SUNDRY NOTICES AND REPORTS ON WELLS

1. TYPE OF WELL GAS		5. LEASE NUMBER SF-078604	
2. OPERATOR MERIDIAN OIL INC.		6. IF INDIAN, ALL. OR TRIBE NAME	
3. ADDRESS & PHONE NO. OF OPERATOR P O BOX 4289 FARMINGTON, NM 87499		7. UNIT AGREEMENT NAME	
4. LOCATION OF WELL 1825'N 1030'E		8. FARM OR LEASE NAME SCOTT COM	
		9. WELL NO. 103	
		10. FIELD, POOL, OR WILDCAT CEDAR H FRUITLAND COAL	
		11. SEC. T. R. M OR BLK. SEC. 3 T31N R10W NMPM	
14. PERMIT NO.	15. ELEVATIONS 5955'GL	12. COUNTY SAN JUAN	13. STATE NM
16. NOTICE OF INTENTION TO: Change Plans			
17. Describe proposed or completed operations

Attached is a revised operations plan, BOPE diagram and anticipated production facilities diagram on the subject well.

Well Name: 103 SCOTT COM 1825'N 1030'E
 Sec. 3 T31N R10W SAN JUAN NEW MEXICO
 CEDAR H FRUITLAND COAL Elevation 5955'GL

FIGURE #1

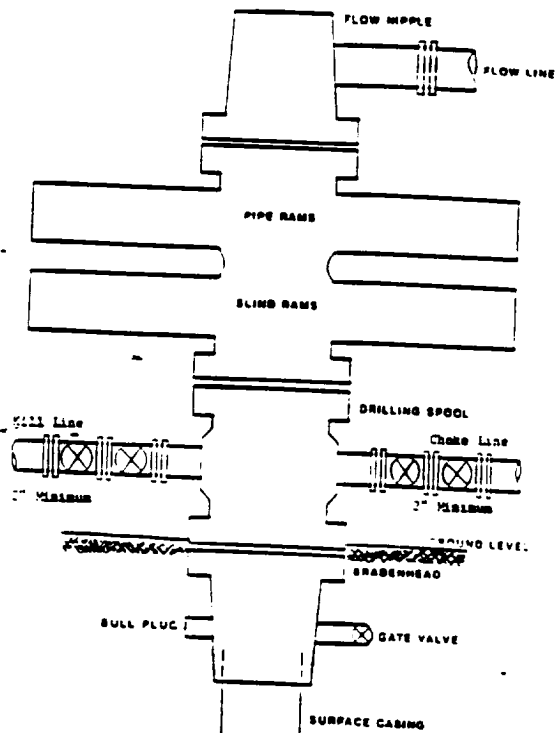
Surface to Intermediate TD - 11" 2000 psi (minimum) double gate BOP stack (Reference Figure #1). Prior to drilling out surface casing, test rams to 600 psi for 30 minutes.

FIGURE #3

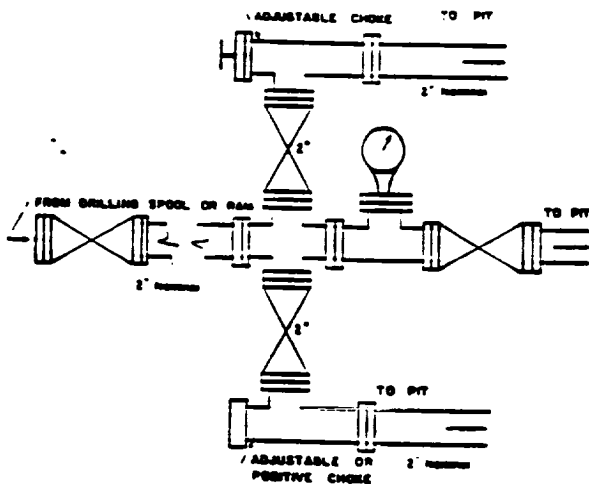
From surface to TD - choke manifold (Reference Figure #3).

FIGURE #2

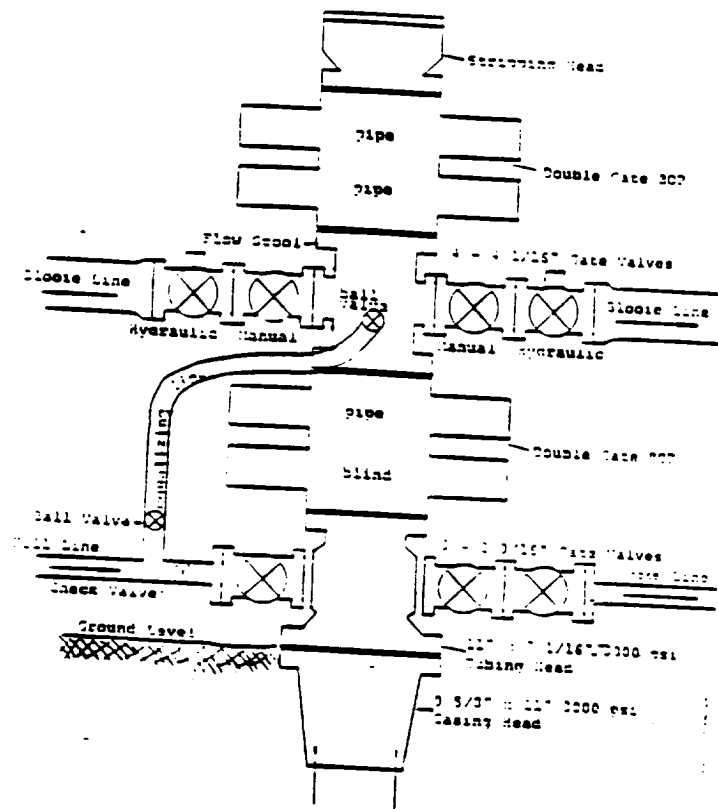
Intermediate TD to TD - 7 1/16" 2000 psi (minimum) double gate BOP stack (Reference Figure #2). Prior to drilling out intermediate casing, test rams to 1500 psi (minimum) for 30 minutes.
